CWSP SYSTEM HARDENING FIELD SCOPING DOCUMENT

PM: [REDACTED]	Project Name: SH - KESWICK 1101 LR 1586	
Notification: [REDACTED]	Region: Northern	City: Redding
Project Manager: [REDACTED]	Division: North Valley	County: Shasta

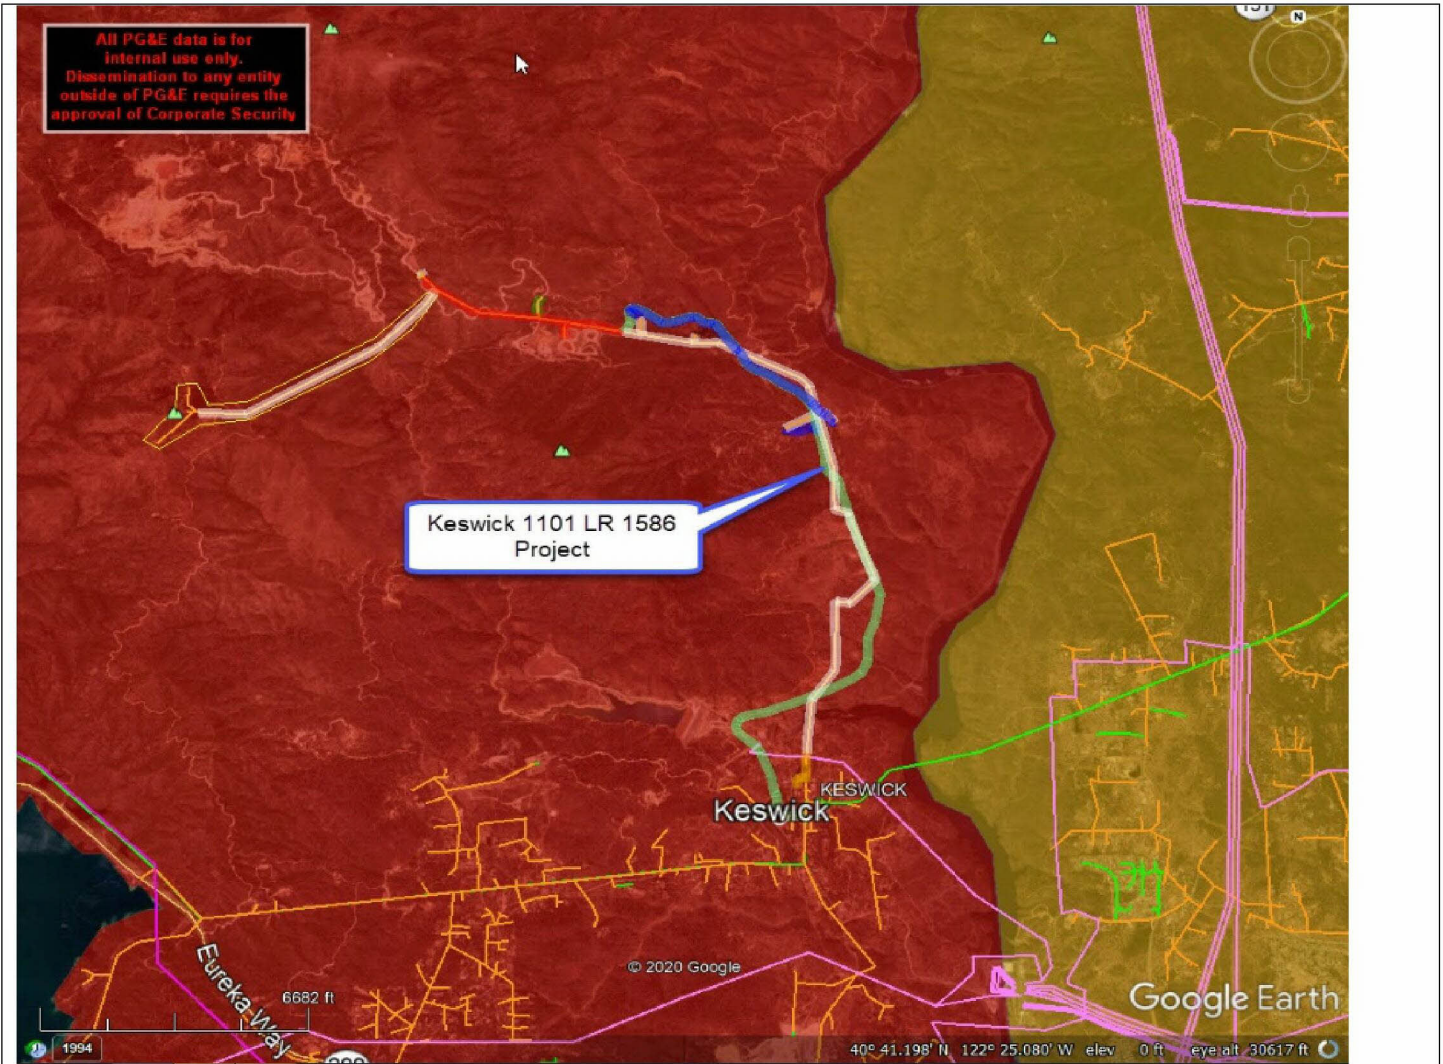
- This area has significant fire history directly impacting the project area. The Carr Fire 2018, Bully Fire 2014, Clover Fire 2013, SHU Lightning 2008.
- All of these fires were not directly in the project footprint area but show the ability of the area fuels to resist containment and have a fire become a major fire.
